SUNDRY NOTICES AND REPORTS ON WELLS

8. Well Name and No.
STREETCAR 15 FED 605H

EOG Resources requests an amendment to our approved APD for this well to reflect a change to a 4-string casing design as attached.

PECOS DISTRICT
DRILLING CONDITIONS OF APPROVAL

Proposed Wellbore
Revised 2/1/18
API: 30-025-42861

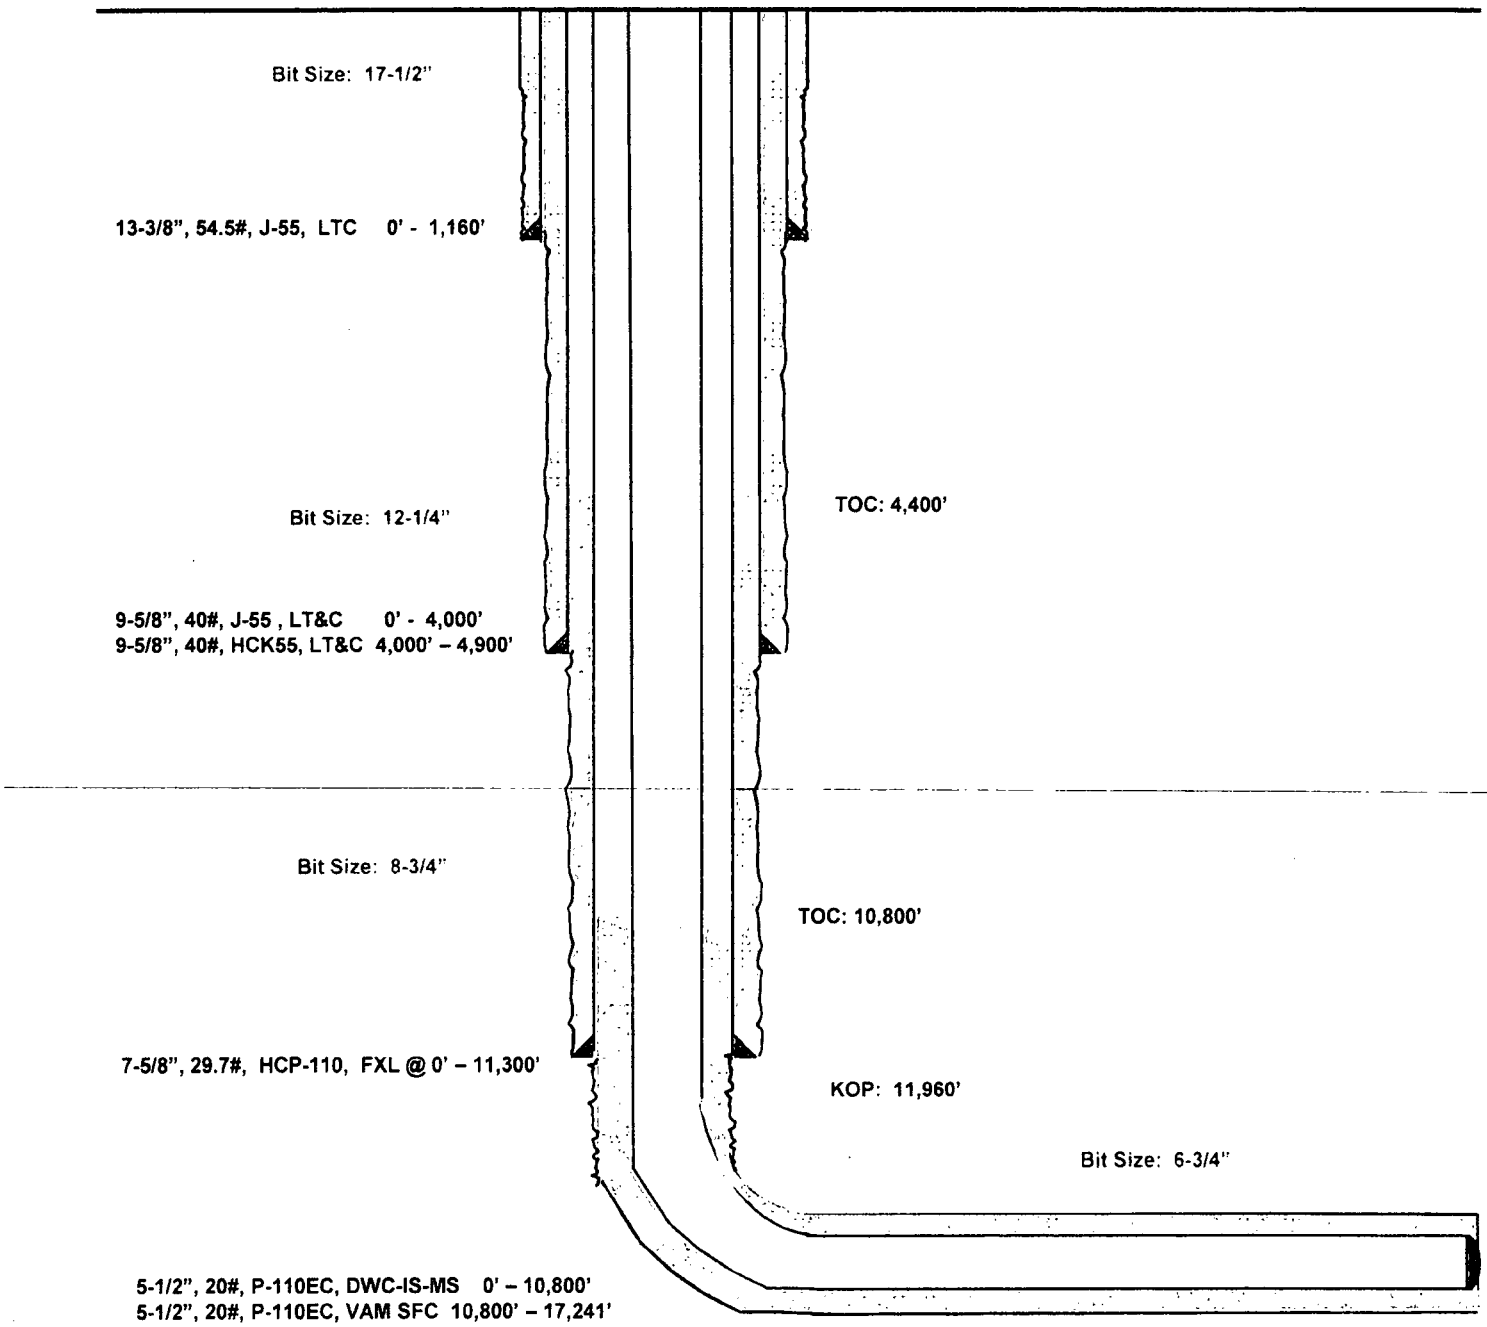
Variance is requested for annular clearance of the 5-1/2" x 7-5/8" to the top of cement.

Variance for annular spacing between 5.5" x 7.625" casings is approved.
